Broward County Commission Regular Meeting

PROPOSAL TO PERFORM FEASIBILITY STUDY OF CIRC HOTEL HOLLYWOOD, FL

RE: **Telecommunications Facility at CIRC Hotel**
KCI Project Number 011900093B

Pursuant to your request, KCI Technologies, Inc. has completed a review of the proposed colocation of the Broward County Public Safety Communication System at this location. The purpose is to provide a recommendation of the use of the CIRC Hotel located at Polk Street in Hollywood, Florida for the colocation of the communication antennas and support equipment. This letter is intended to provide supporting documentation to the overall feasibility study proposal prepared by Motorola Solutions and Broward County Emergency Management Division.

Outer Parapet Microwave Design Layout

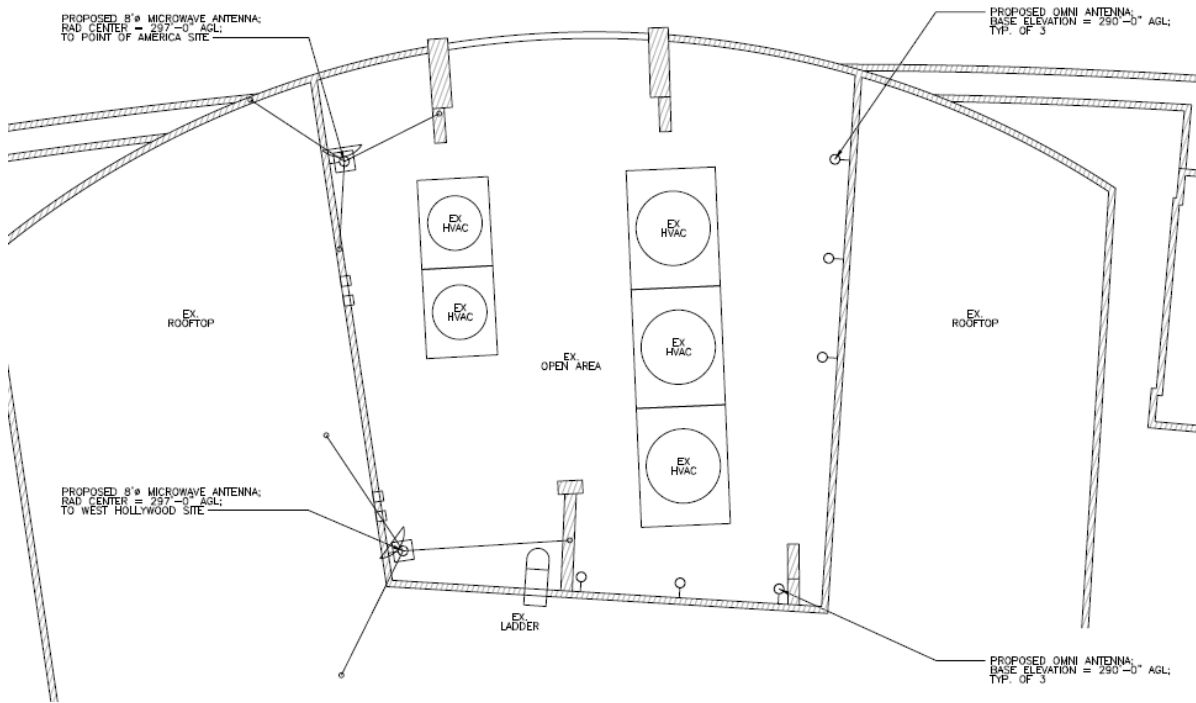
The best location of the microwave antennas is on the outer parapet wall. This provides the clearest path without any shadowing or RF emission hazards. Microwaves have a very tight bandwidth (1.3 degrees), but have a very concentrated RF emission, which requires the area in front of the microwave to be left clear to be in compliance with the FCC guidelines on human exposure. Due to the size of the microwave dish, 8-ft and the desired azimuths to the receive antennas, the microwave will need to be elevated above the parapet wall to be able to rotate it. This is going to be very difficult to achieve with the high wind speed and limited area to attach to on the parapet wall, so we had to use multiple standoffs

attached back to the parapet wall as well as the roof surface to achieve. This will also be very visible. Please refer to the photo above for an indication of the location of the microwaves viewed from street level as well as plan view shown below.

Inner Parapet Layout Diagram

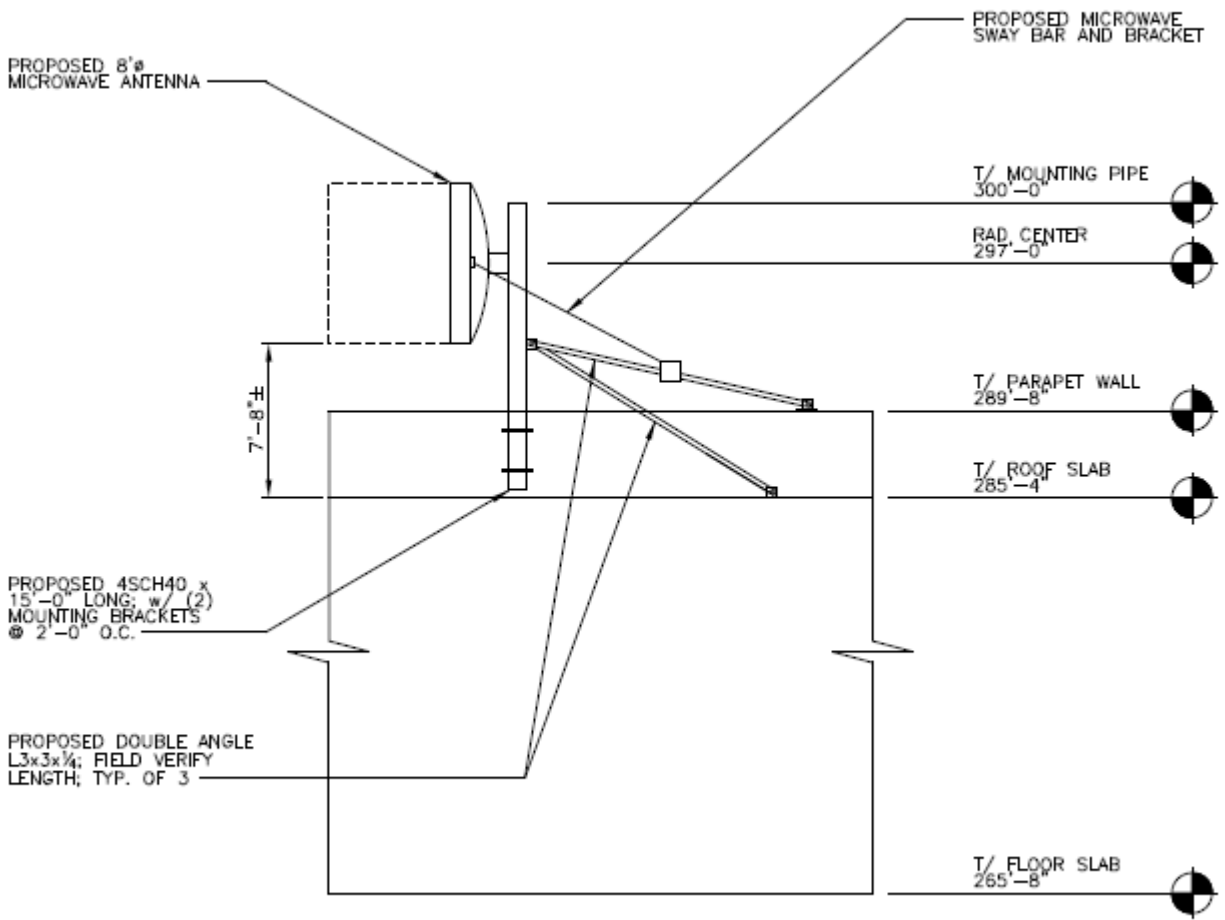
KCI also examined a location of the microwave antennas on the inner parapet wall. To achieve the RF safety of this location, either the roof in front of the microwave will need to be kept clear or the microwave will need to be elevated to ensure the path is clear. KCI elevated the base of the microwave 8-ft above the roof elevation. Refer to diagram below showing the microwave placement. The beam width is very tight, so there will not be much scatter or spread of the RF below the base of the microwave.

Most microwave designs are not necessarily a structural concern, i.e. a capacity challenge, but a serviceability challenge. As stated before the beam width is very concentrated so any movement can result in a degraded signal or loss of data on either side of the link. For those not familiar with digital communication versus analog, signal loss will leave holes (missing words, etc.) in communication versus the old analog where the single may sound garbled, but still understandable. The loss of data can have significant impacts depending on the severity as a computer can recreate some, but not necessarily all the gaps, leaving holes in pictures, video or more importantly files that can't even be opened as they are corrupted. It is important that under the most intense wind conditions that microwave deflections be limited to as near to zero as possible. This requires significant stabilization efforts for the three items contributing to the possible movement, the microwave itself, the mount and the underlying structure. Self-Supported towers are designed with large bases and microwaves are generally placed in areas with wide face widths to resist movement under extreme conditions. Buildings are generally good at resisting movement as well, but the mounting systems placed on buildings often don't have the same stability mechanisms as those used on communication towers. It is expensive to construct and often involve numerous penetrations into the "skin" of the building, either the side or roof, which can lead to long term water intrusion challenges because any penetration has a high potential of leaking. This particular building and mounting system is no exception.

Microwave Mounting Detail Outer Parapet Wall

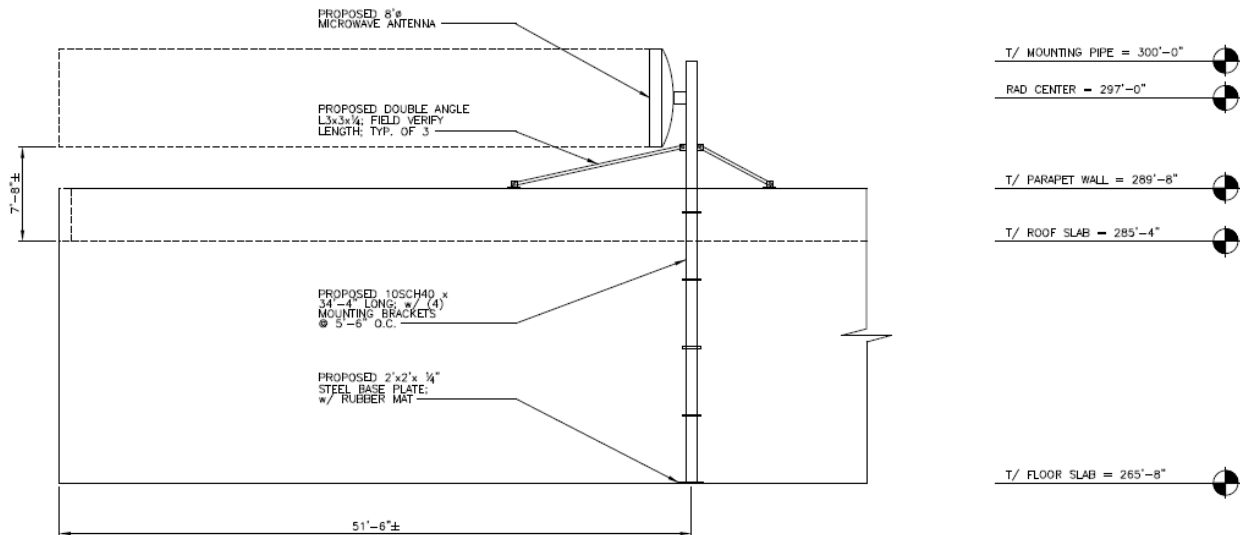
For the outer parapet wall design, KCI utilized a 4-inch pipe mast with four kicker arms to provide sufficient lateral restraint of the smaller pipe diameter. Two will be to the adjacent parapet wall and two will be down to the roof floor level. We also will attach stabilizer arms to the outside of the microwave antenna in, which will then be connected to one of the kicker attachments, either on the wall or the roof slab.

Column interference in Equipment Room Location

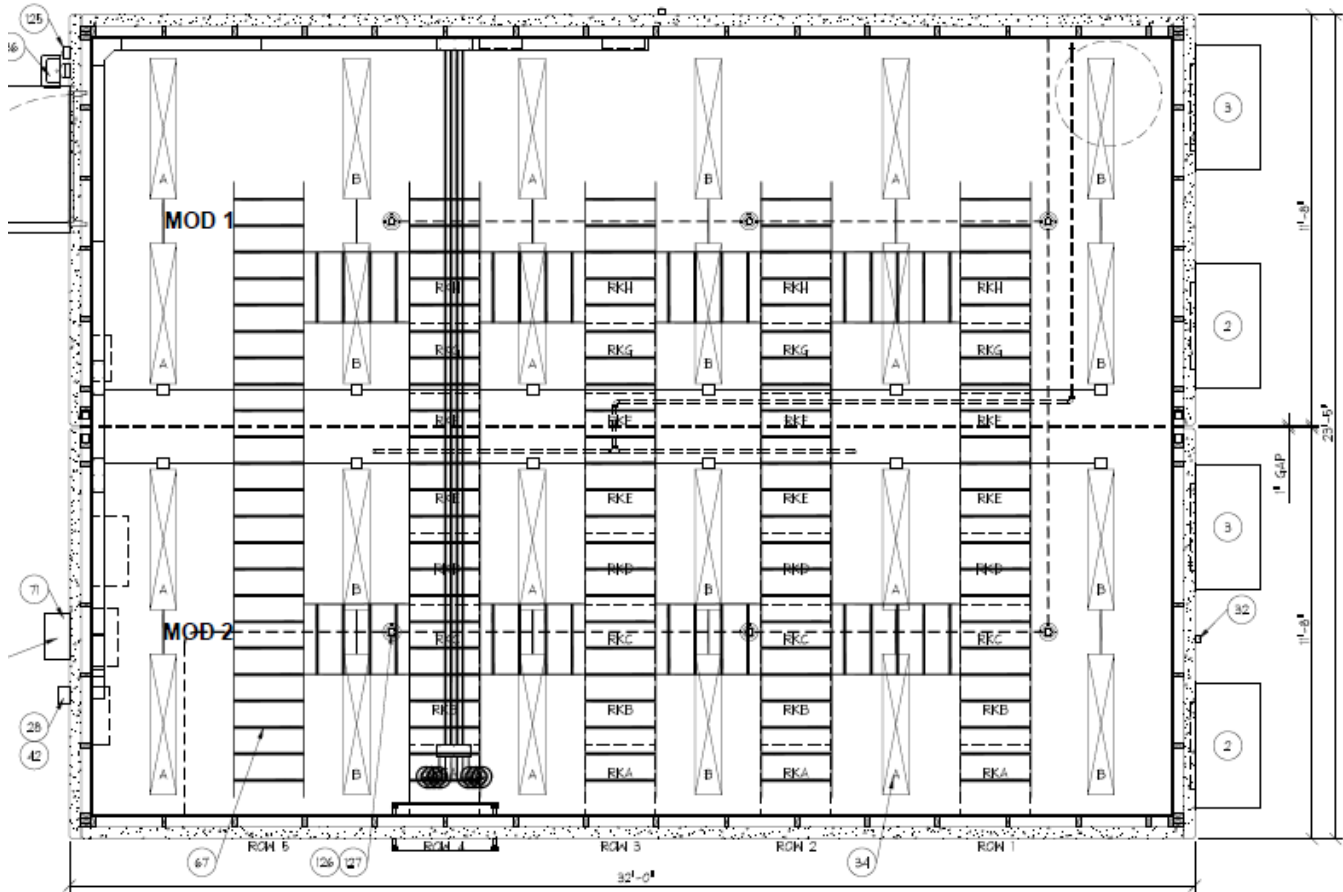
Fire Suppression System to be Relocated

Raised floor slab and evidence of standing water

Vents near wall penetration location

Inside of the boiler room, in the proposed location of the equipment room, there is a column impeding the floor plan for the equipment racks. Above diagram is a typical shelter layout diagram. This is a preliminary layout for the equipment to be used for this site. The column will interfere with the normal walkway of this layout design and force a constrained option for the rack layout. Currently there is one empty row, with the column some of the proposed racks will need to be relocated to the empty row and then remove future upgrade capacity. This is even more critical during transition periods as the new equipment is often temporarily located in these open areas and then when the cutover is complete, they are relocated to the permanent locations when the old equipment is removed. Without the ability to utilize these spaces, technology upgrades and equipment swaps could result in system downtime, which is unacceptable for emergency communications.
